This **ERRATA Sheet** describes the latest known issues of easYgen-3000XT series devices. The following short identifiers are used:

| Short identifier: | Affected products: | Related Technical Manual(s): |
|-------------------|--|------------------------------|
| XT-3K | easYgen-3000XT series | |

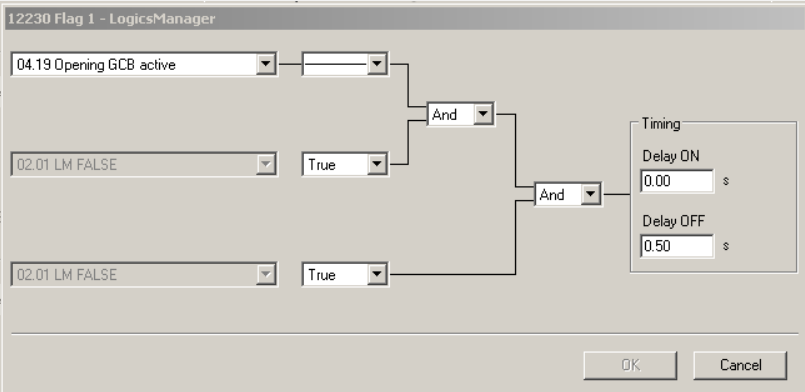
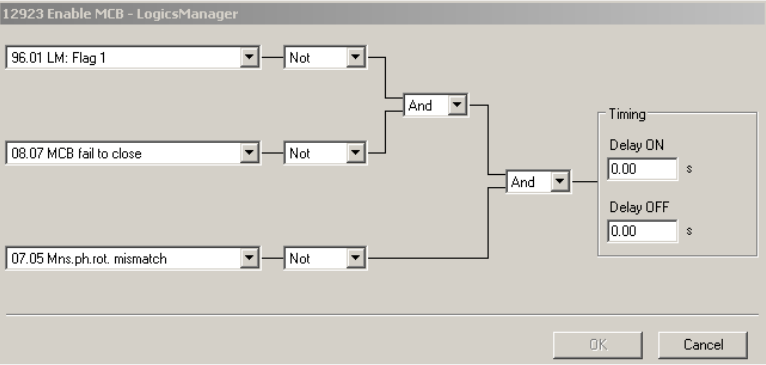
| # | Date / Affected | Description | |
|-----------------------------|---|--|------|
| | 2023-11 XT-3K | <ul style="list-style-type: none"> Event log entries "Open command GCB": If the opening of the breaker failed , it could happen that the corresponding open command was permanently entered in the event log. Now a new entry can only be made if the breaker was opened in the meantime, or a close command was active. The configuration of Flexible Limits 19 and 20 did not work correctly. The configuration of the limit 19 had an impact on limit 20 and vice versa. This is fixed now. The LDSS function in Mains Parallel Operation (MOP) being in mode Interchange, Closed transition or Open transition did not work correct. It could lead to a wrong start and stop behavior. This is fixed now. Software versions 2.12-1 and older do not meet the specified maximum number of devices on Ethernet bus. This is fixed now. A buffer is now installed in software 2.12-4 and 2.15. For more information refer to the latest technical manual from Woodward. | |

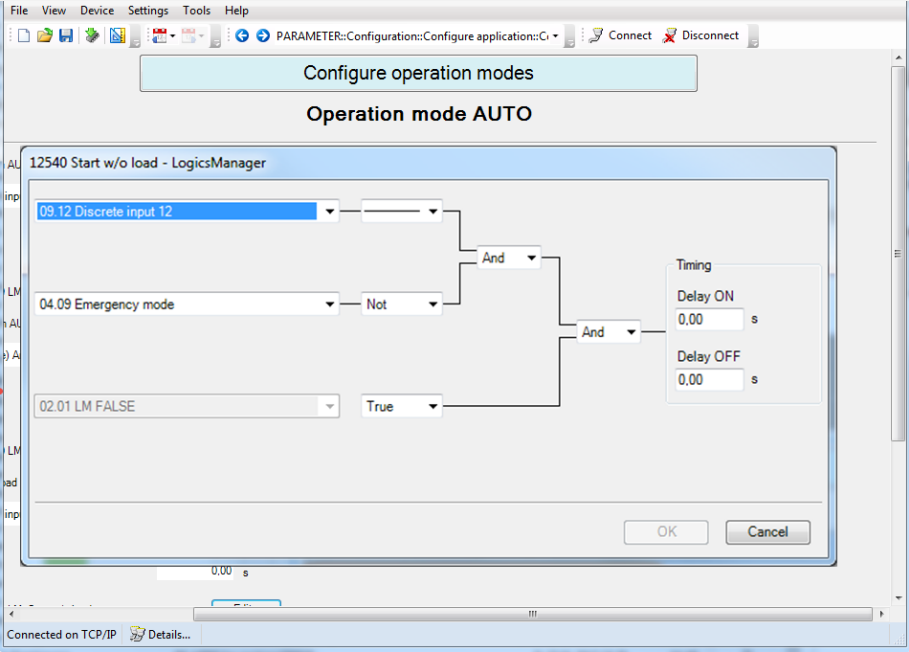
| # | Date / Affected | Description Remarks ToDo |
|-------|---------------------------|---|
| XT-3K | | <p>If emergency run is active, "GCB auto unlock" can cause simultaneous deadbus closure of GCB and MCB if mains return during the "GCB open pulse". This can only happen in parallel logic if the "GCB open time pulse" (5708) is configured higher or same than 2 s. (This is because the mains settling time – which is shortened to 2 s in emergency case – and the "GCB open time pulse" are mismatched.)</p> <p><i>Will be updated asap by next revision.</i></p> <p>Possibilities to avoid this: If possible, configure "GCB open time pulse" (5708) shorter than 2 s. Configure a delay for enabling the MCB triggered by "04.19 Opening GCB". To do this, define an internal flag (e.g. Flag 1) and pass this flag to the LogicsManager "Enable MCB":</p>   |

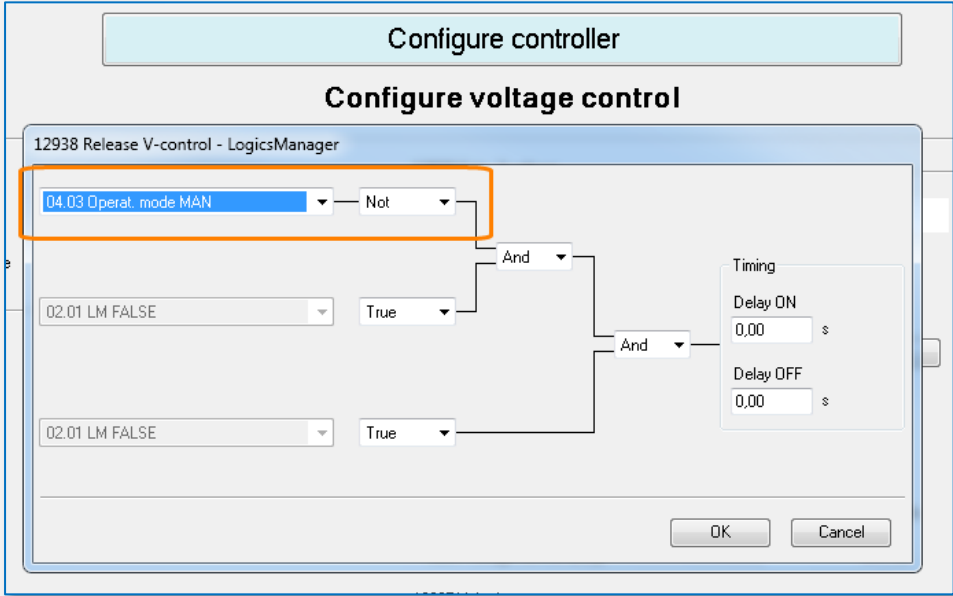
| # | Date / Affected | Description | |
|-----------|-----------------------------|-------------|--|
| | 2017-01-31 | | The Auto mode "Start without load" ID12540 in conjunction with emergency run causes a frequently GCB close and open command, if "Enable MCB" ID12923 is removed (False) to the same time. (There is no internal prioritization for these two conflicting tasks.) |

| # | Date / Affected | Description | |
|-----------|-----------------------------|-------------|--|
| | | | To avoid the auto mode "Start without load" ID12540 is active in exactly the same time the emergency run happens, do following: ((see next page)) |
